# UNITED STATES PATENT AND TRADEMARK OFFICE

### Office Action Summary

10/524,774

MAYER-GINDNER ET AL.

FIG. 1A

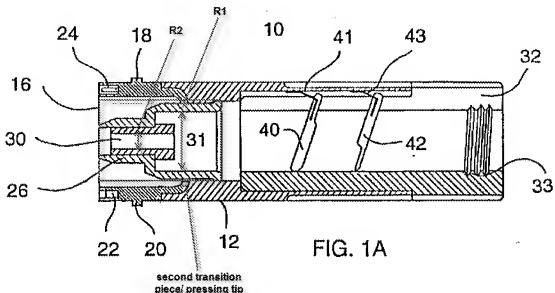
28. [Claims 5, 6 and 8] Wilden is discussed above, but is silent with regards to a second transition piece for introducing laser radiation into the optical waveguide. Chou discloses a connector adapter for coupling a laser source to an optical fiber (abstract). The second transition piece is labeled below. Chou discloses that this piece is generally conical shaped (Col 7, lines 6-48); this is interpreted as a conical tapered inner surface shaped in the form of a hollow cylinder, as seen below. The pressing tip accommodates the end of the optical waveguide (28, Fig. 1C) and comprises a through bore (30 and 31) having a radius R1 and R2 (labeled below). The limitations "wherein the focusing region generated in the focusing sleeve of the laser radiation is immediately ahead of the entrance opening of the optical waveguide" (Claim 5), "into which the end portion of the coated optical waveguide is inserted, in particular glued" (Claim 8), and "into which a de-coated end portion of the optical waveguide is protruding with its entire length" (Claim 8) are interpreted as intended use. Intended use/functional language does not require that the reference specifically teach the intended use of the element. A recitation of the intended use of the claimed invention must result in a structural difference between the claimed invention and the prior art in order to patentably distinguish the claimed invention from the prior art. If the prior art structure is capable of performing the intended use, then it meets the claim.

31. [Claims 9-11] Chou discloses two holders (22 and 24, Fig. 1A) and coupling portions (18 and 20, Fig. 1A) for detachably connecting the second transition piece and the laser source (Col 6, lines 25-54). As Chou teaches a cylindrical device, these holders (22 and 24) are considered to be disposed along a ring.
